# NEW ENTRY FOR CHICOT ELEMENTARY SCHOOL LITTLE ROCK SCHOOL DISTRICT

CHICOT ELEMENTARY SCHOOL  
11100 CHICOT ROAD, MABELVALE, AR 72103

As-Builts  
CSUSA  
9/18/2023

**3 PLUMBING PLAN**  
SCALE: 1/8" = 1'-0"

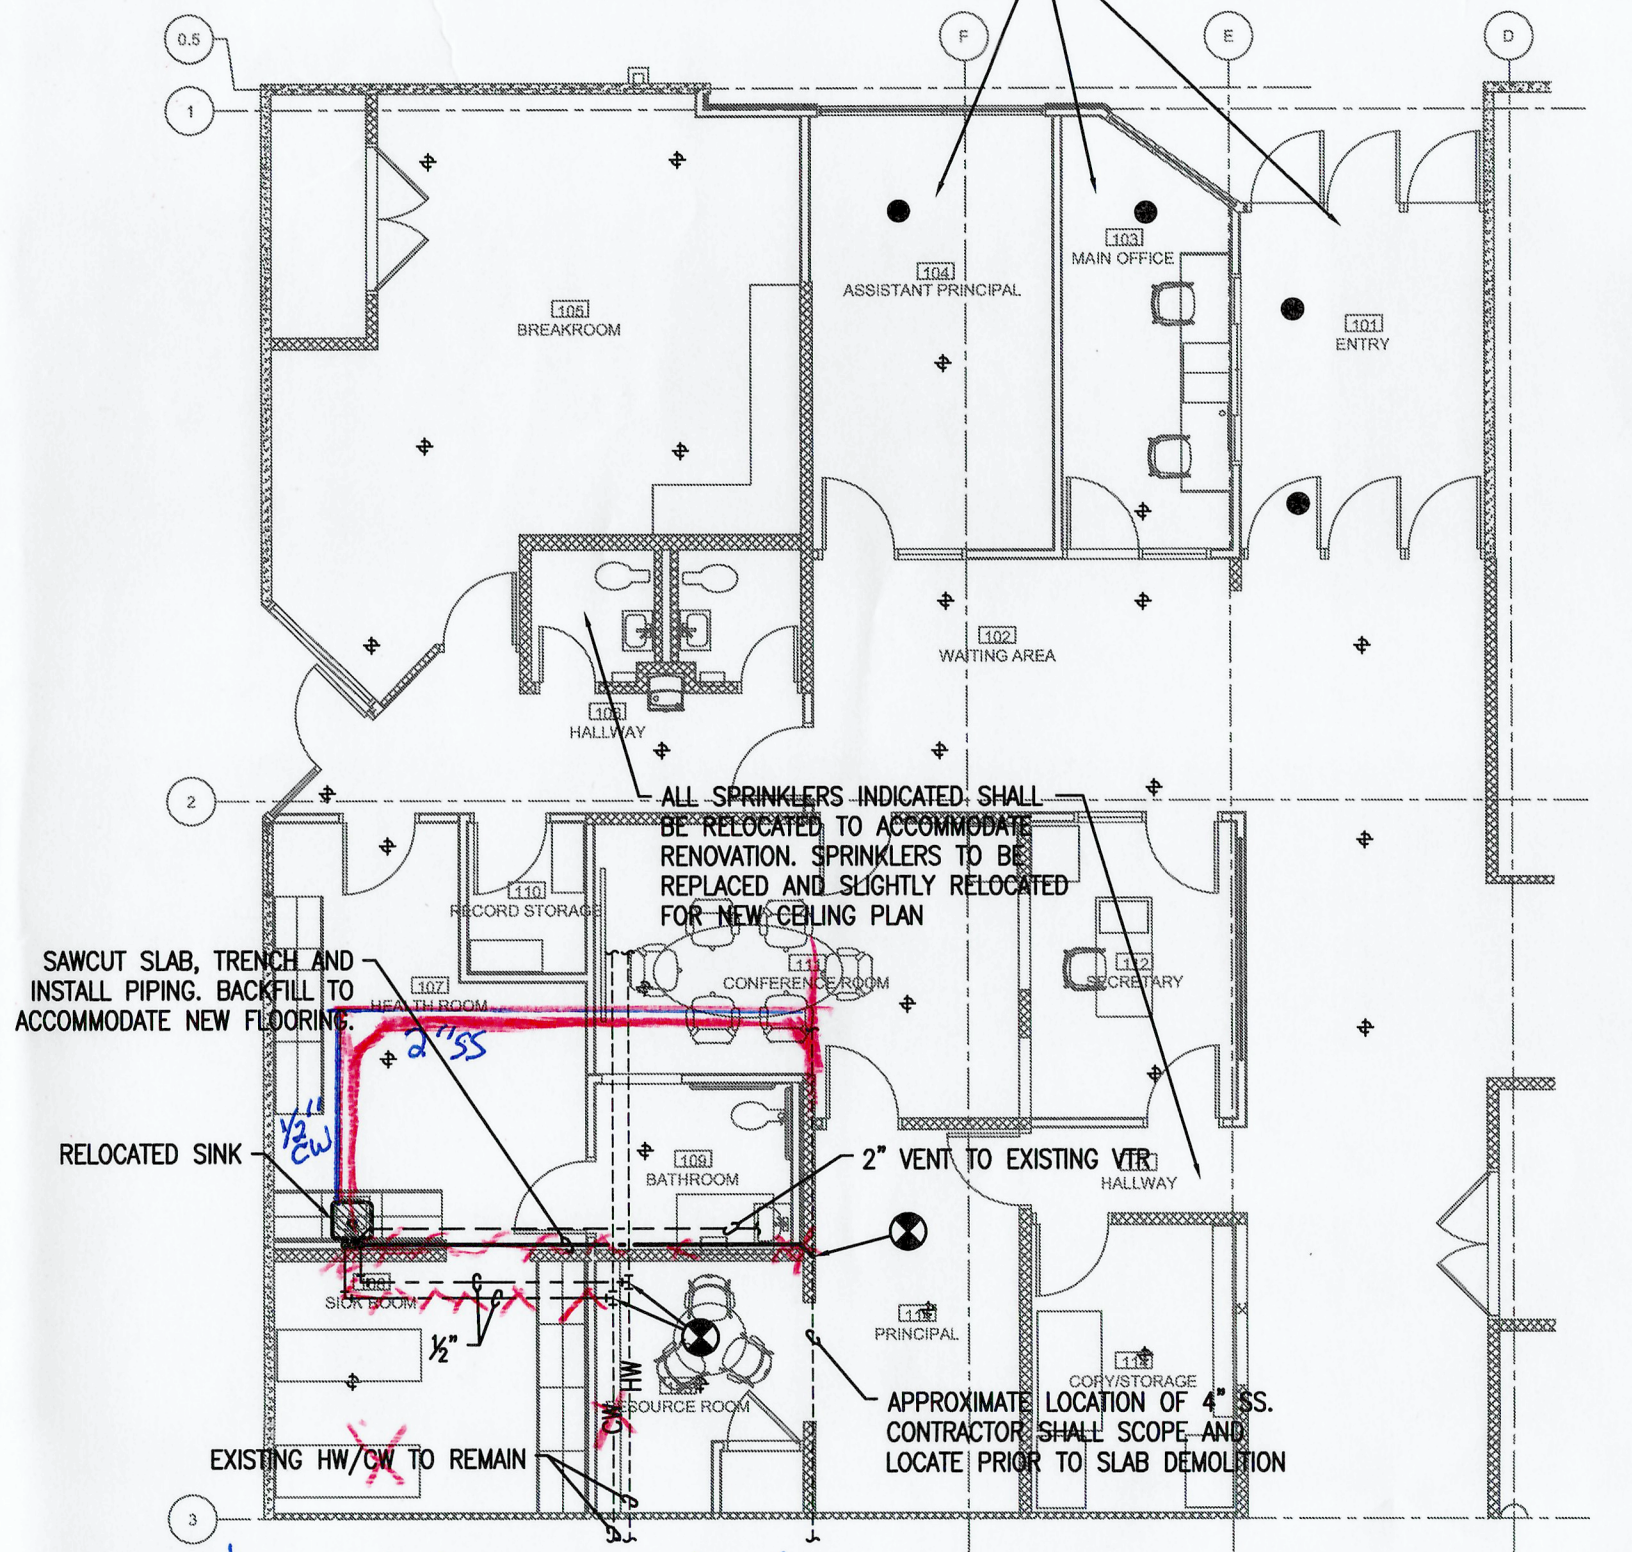
*CW does not run overhead  
Had to tie CW under slab to  
Existing CW that feed sink.  
CW shut off is @ street.  
No way to shut off inside.*
